**Tuesday August 28, 2018**  
**Medway Planning and Economic Development Board**  
**155 Village Street**  
**Medway, MA 02053**

**Public Review – Minor Site Plan for Medway Community Church, 9 and 11 Public Slocumb Place:**

### **Re: Medway Community Church Site Plan**

**Re: Medway Community Church  
Site Plan Review  
9 & 11 Slocumb Place  
Medway, Massachusetts**

LANDSCAPING PLAN  
SCALE: 1" = 20'

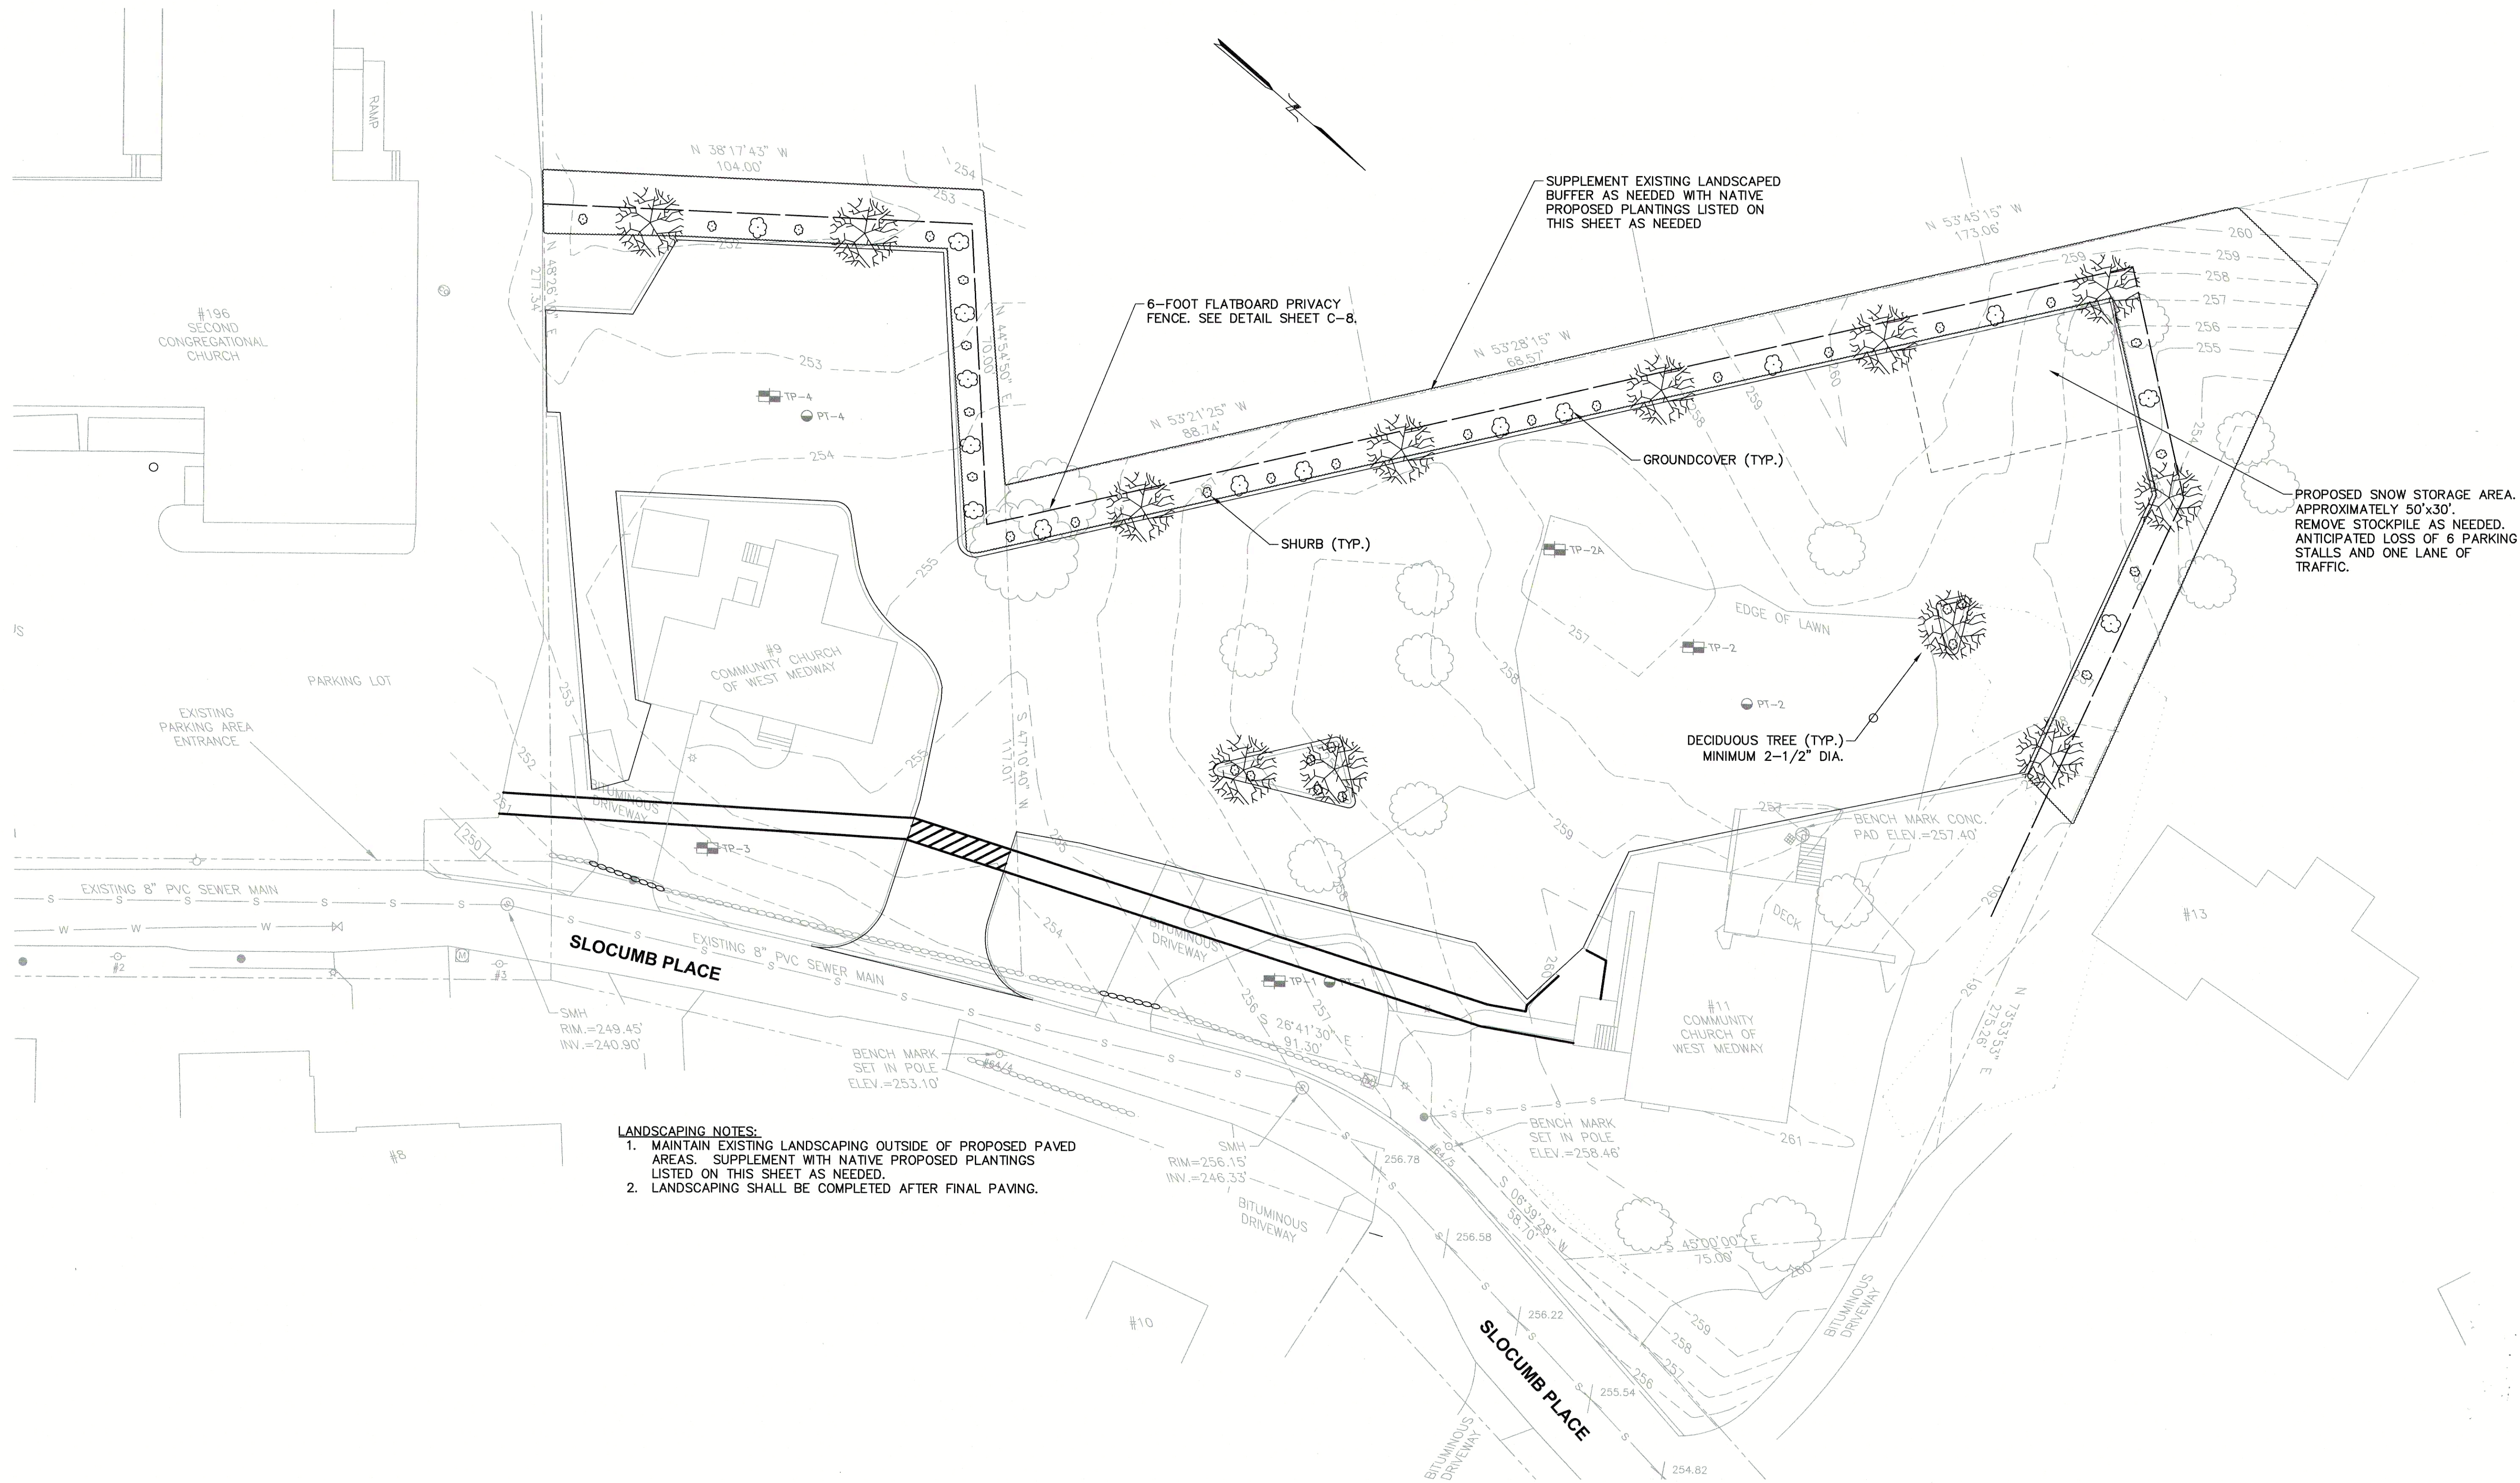
10. Section 204-5 D. (7) requires that a landscape plan be prepared by a landscape architect. There is no indication that a landscape architect prepared the landscape plan and no waiver is requested. The Landscape Plan consists primarily of notes on the plan rather than drawings illustrating the proposed plantings. This is due, in part due to retaining existing vegetation and fitting in new plantings where feasible. **The Landscape Plan now shows proposed trees and shrubs with a note “as needed.” A waiver is requested from the requirement that the plan be prepared by a Landscape Architect. OK**

- TT 8/24/18 Update: In our opinion, this item has been addressed.
- 7) The Lighting and Landscaping Plan does not show evidence that a Landscape Architect licensed in the Commonwealth of Massachusetts prepared the layout. (§204-5.D.7)

- 8) Proposed plantings for the Project are required to have both the common and Latin name provided. (§204-5.D.7)
- *THI 8/14/18 Response: Acknowledged. The plans shall be updated to include both common and Latin names of the proposed plantings.*

- *THI 8/14/18 Response: The parking areas will be screened from the public right-of-way, side, and rear of the site through the use of existing stonewalls, shrubs, trees, and proposed supplemental landscaped areas. Existing landscaping shall be maintained to the greatest extent possible. A waiver is proposed for this requirement.*

PLAN OF LAND

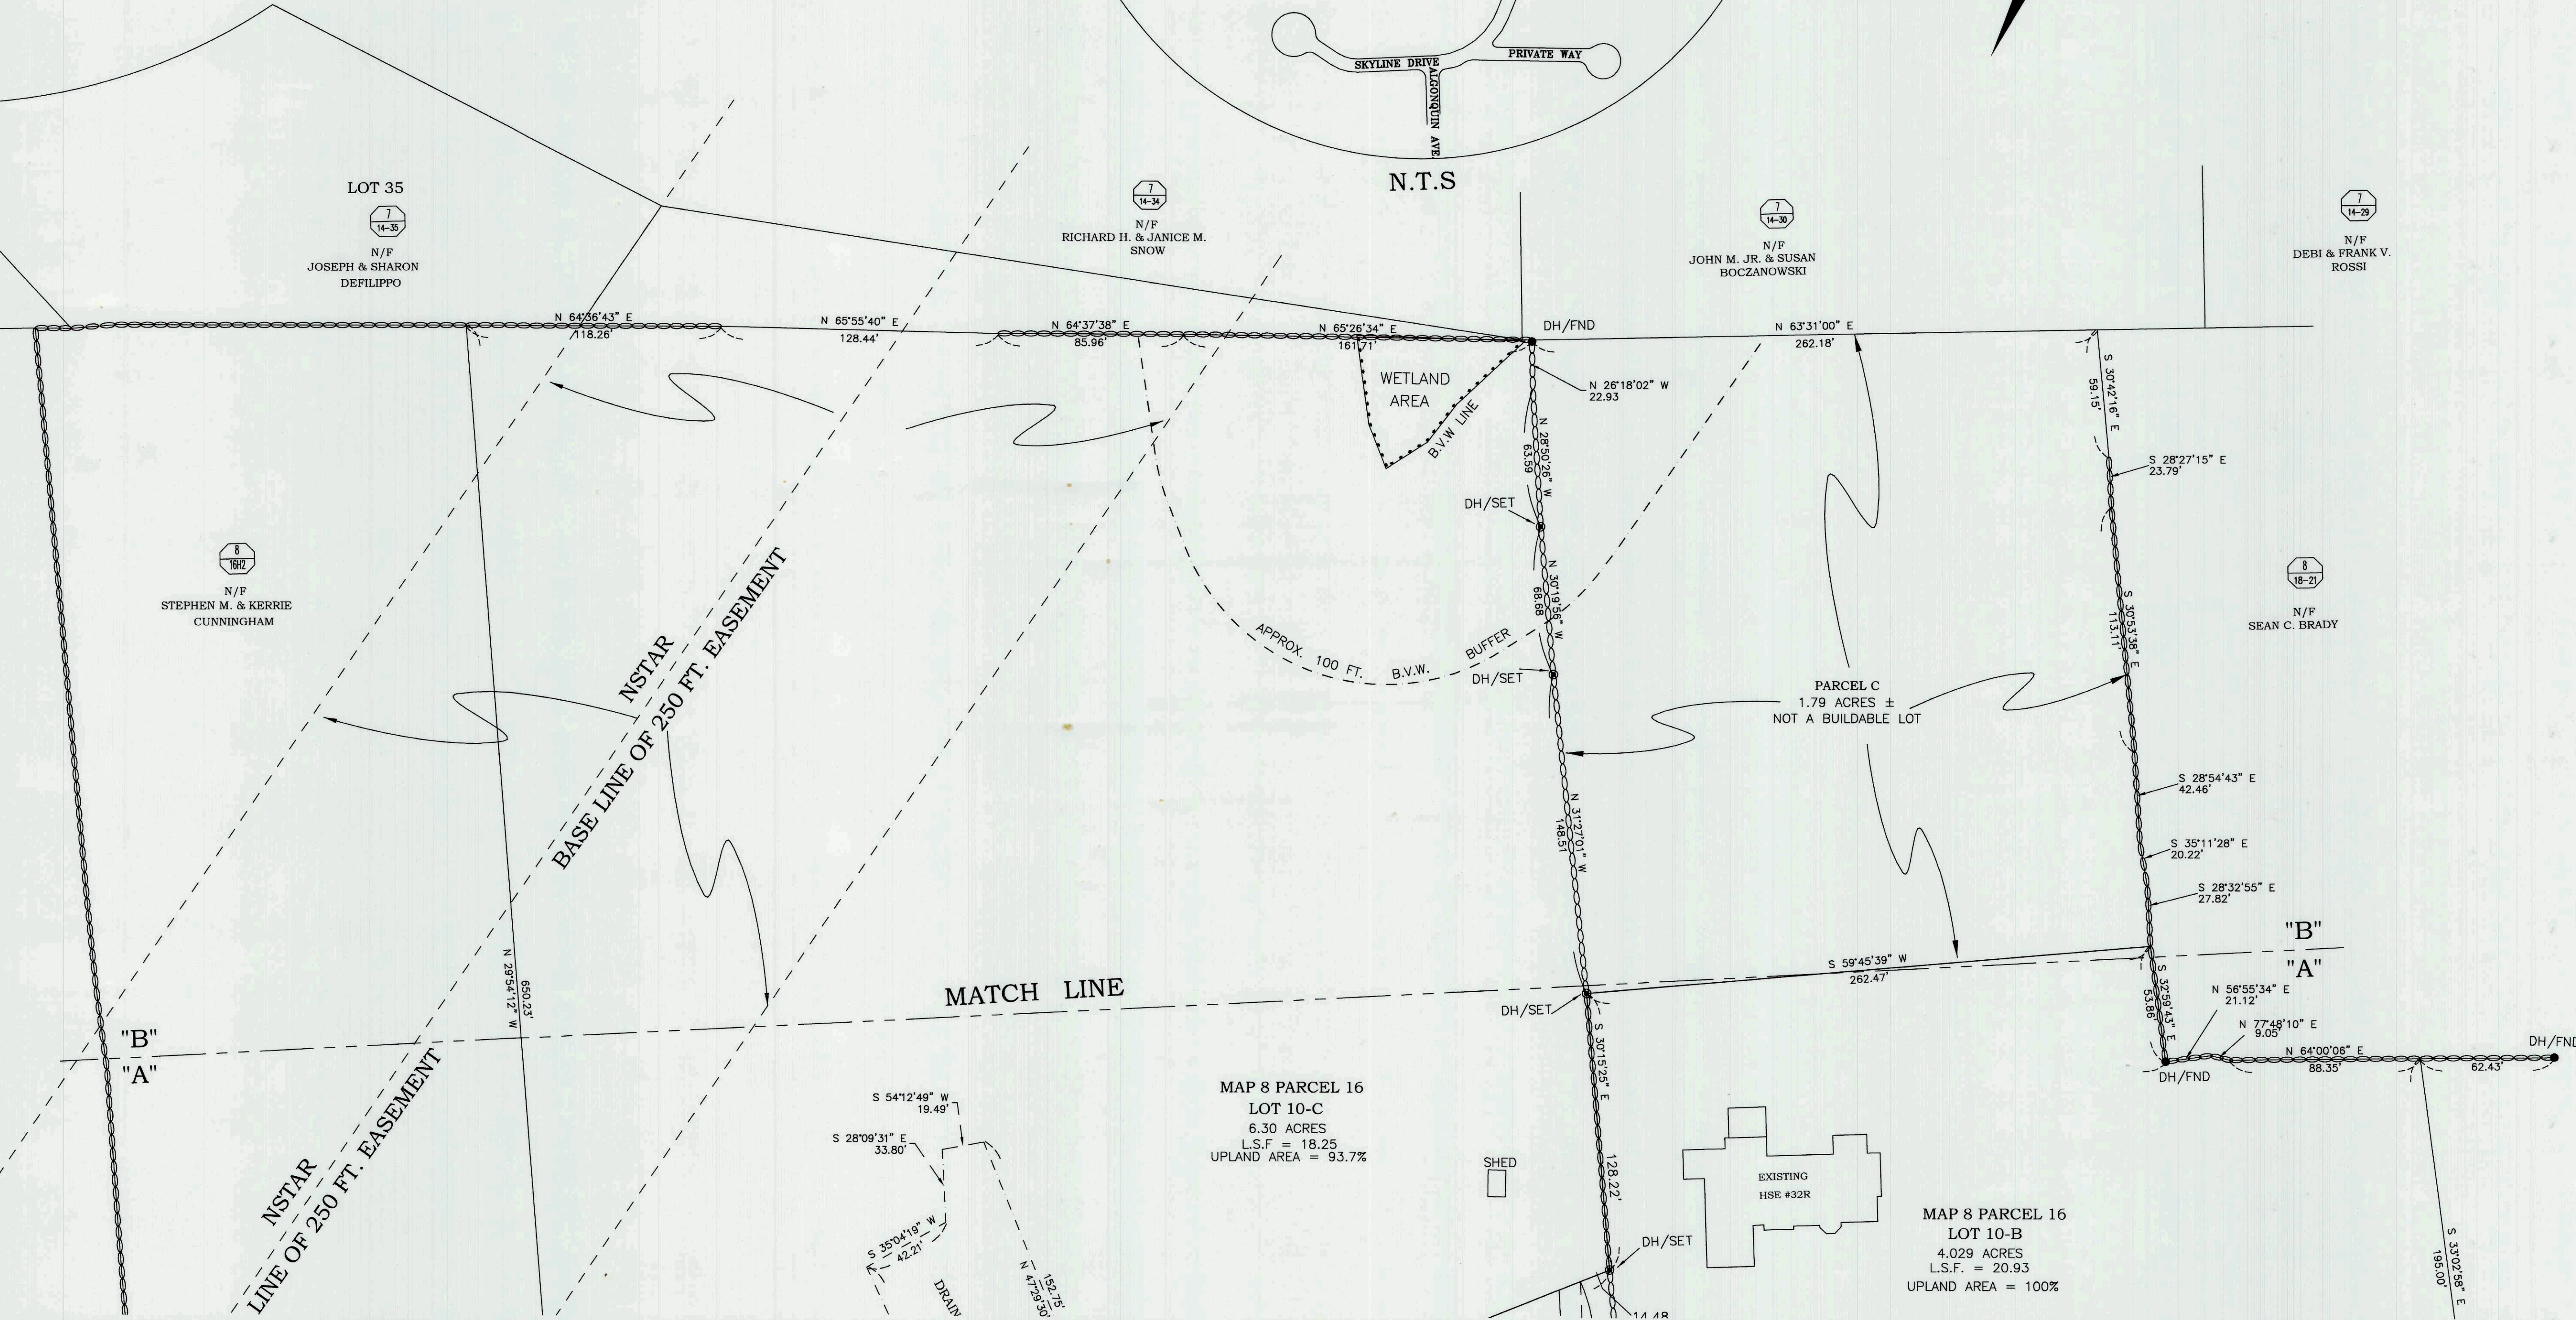
Consultant Carlucci noted that planned easement be shown on plan but it is not a requirement.

1. The plan clearly meets the substantive and technical requirements for ANR endorsement.
2. Sections 3.2.9 requires that the distance between structures and any new lot lines be shown. The distance to the new lot line from the existing house is not shown. However, the new lot line is an extension of the existing side lot line on the west side of the lot so such a distance would not serve any purpose.
3. Section 3.2.10 requires that easements be shown on the plan. The existing easements are shown. However, the applicant has indicated an intent to add an easement to Lot 10-C. While not a requirement, it would be useful to future owners to show that easement on this plan
